Video Products Technical Bulletin 30-2004-096

SUBJECT: DAMAGE TO VIDEO OUTPUT IC

MODEL: PVM-14L5
 PVM-14L5/1
 PVM-14L5/2
 PVM-14L5/3
 PVM-14L5/4
 PVM-20L5
 PVM-20L5/1
 PVM-20L5/2
 PVM-20L5/3
 PVM-20L5/4
PVM-D14L5A
PVM-D14L5A/1
PVM-D14L5A/2
PVM-D14L5A/3
PVM-D20L5A
PVM-D20L5A/1
PVM-D20L5A/2

Figure 1

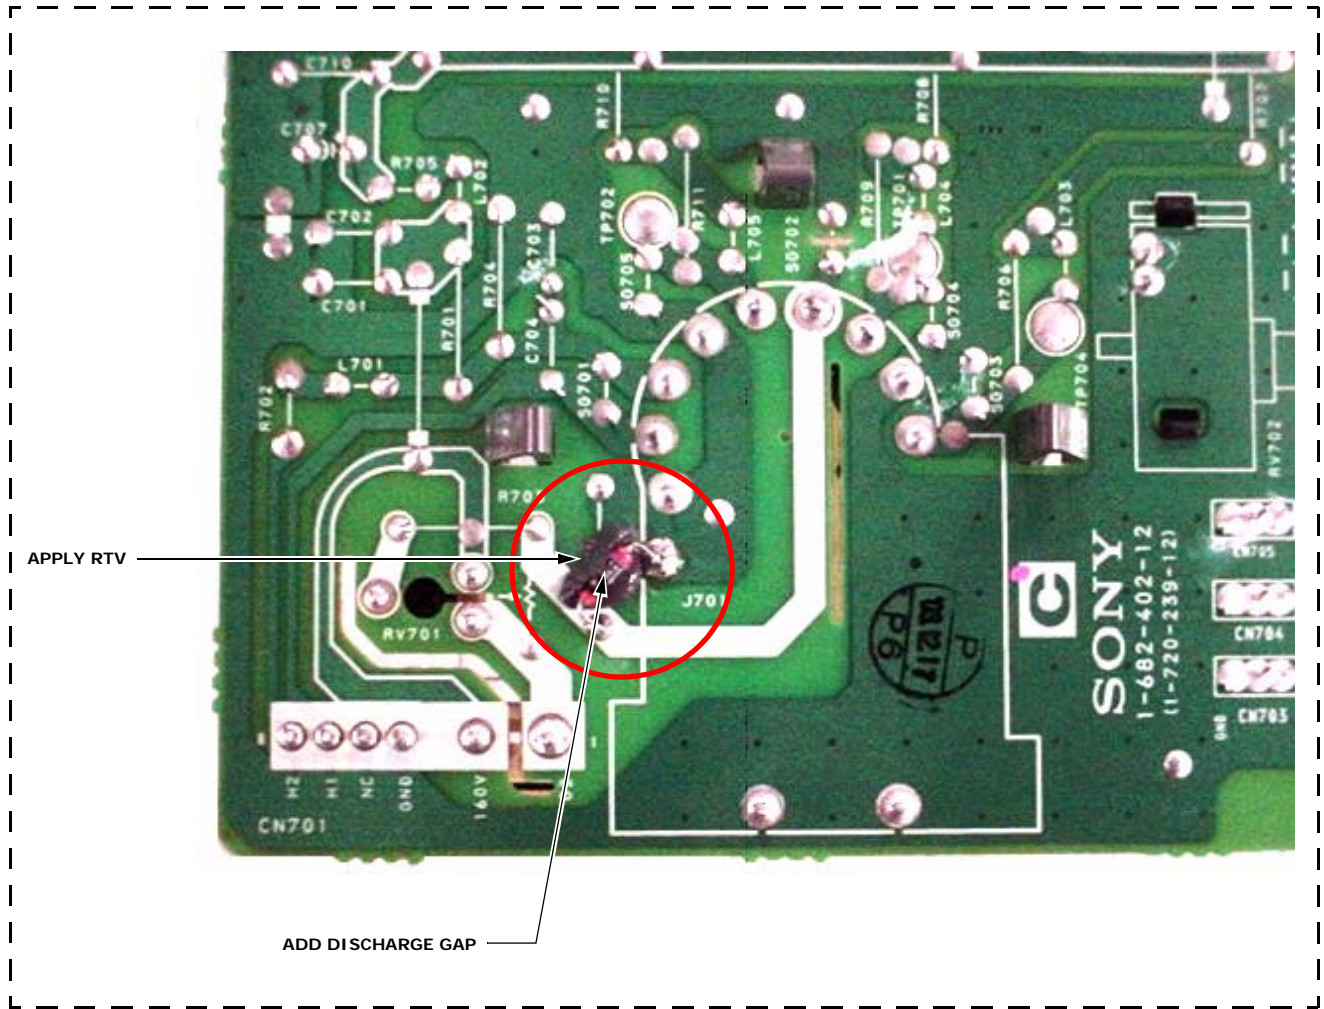
The video output IC (IC701, IC702 and/or IC703) on the C board may become damaged.

1. Solder a discharge gap between G2 and GND as shown in Figure 1.

NOTE: Maintain a clearance of 1 mm to 7 mm between the discharge gap and the board. Do not allow the discharge gap to touch the board.

2. Apply RTV between the discharge gap and the board.
3. Perform the modification procedure in Technical Bulletin 30-2003-149 if it has not already been performed.

NOTE: The modification protects the video output IC from damage due to a voltage surge.
